# ADDENDUM NO. 1

Donnelsville Water System  
Clark County, Ohio

Project No. 223879.01

May 15, 2026

## WATERLINE TRENCH DETAIL OUTSIDE PAVEMENT AREA

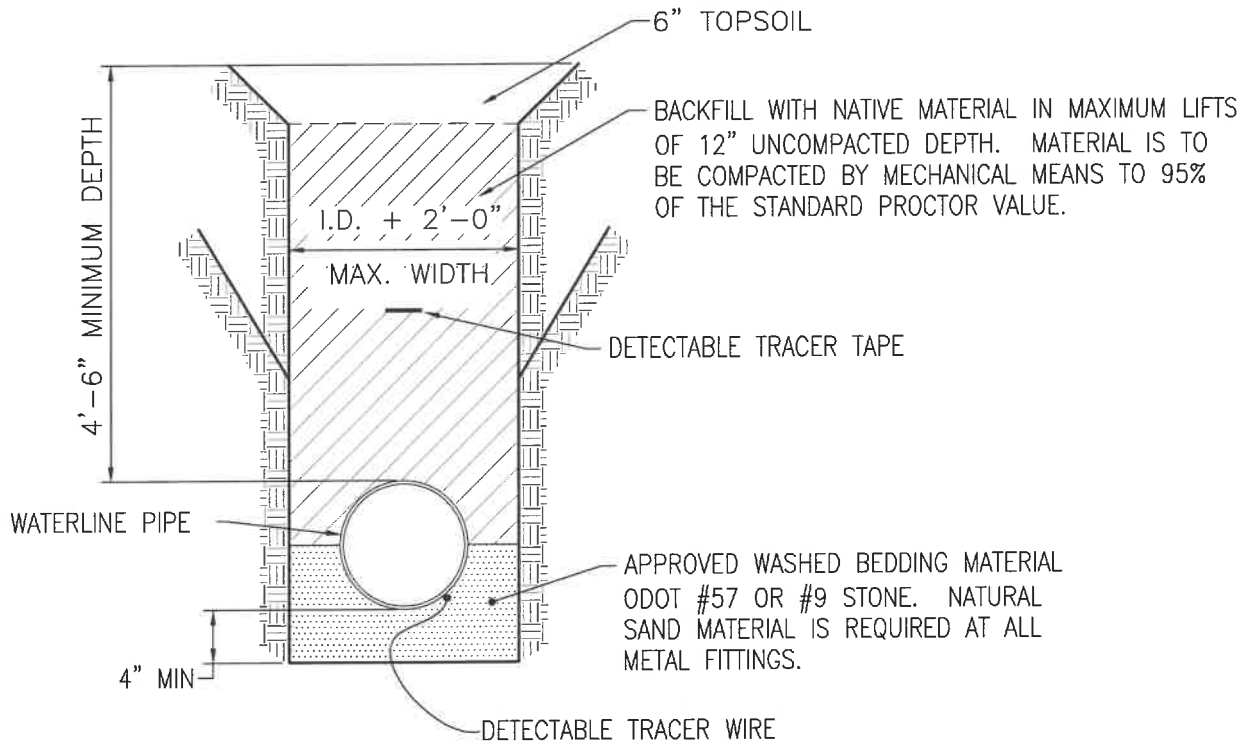
ITEM NO. 5- CONSTRUCTION DRAWINGS – DONNELSVILLE WATER SYSTEM

DRAWING SHEET #6

INSERT: WATERLINE TRENCH DETAIL OUTSIDE PAVEMENT AREA REVISED  
(Addendum Drawing #1)

DELETE: WATERLINE TRENCH DETAIL OUTSIDE PAVEMENT AREA

PIPE BEDDED TO ITS CENTERLINE IN COMPACTED GRANULAR MATERIAL, 4-INCH MINIMUM UNDER PIPE. COMPACTED GRANULAR OR SELECT MATERIAL TO TOP OF PIPE. (APPROXIMATELY 90 PERCENT STANDARD PROCTOR, AASHTO T-99)
